Amendment to the Drawings:

REMARKS

FIG.2B

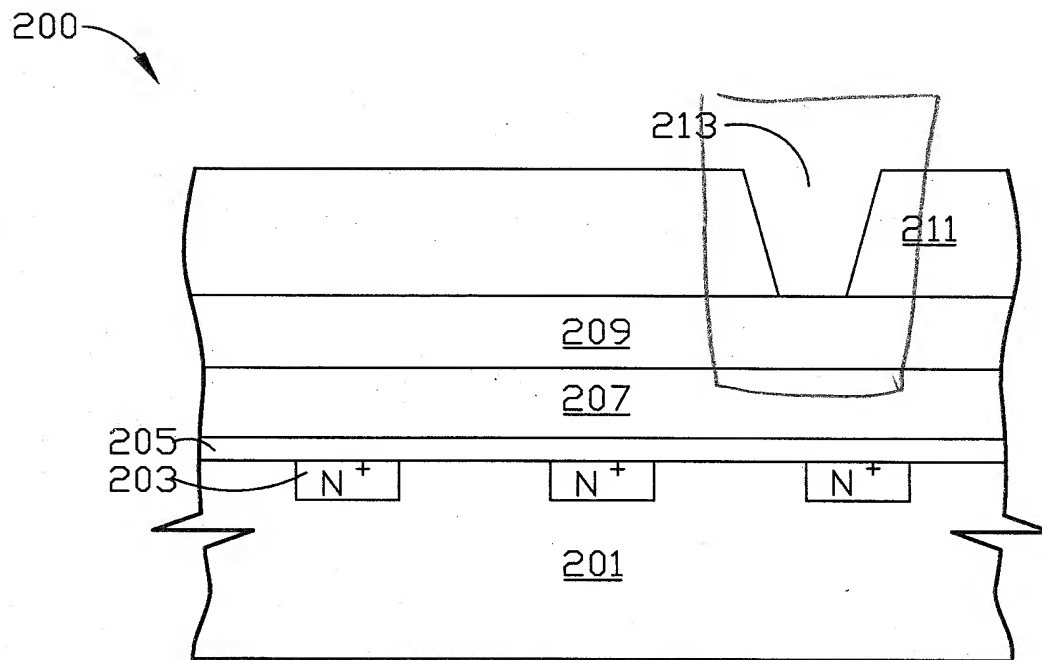
The attached sheets of drawings include changes to FIGs. 2B-2H. These sheets, which include FIGs. 2A-2H, replace the original sheets including FIGs. 2A-2H. In the amended FIGs. 2B-2H, first opening 213 and contact plug 216 are formed in the second dielectric layer 211 and the first dielectric layer 209, and are connected to polysilicon word lines 207.
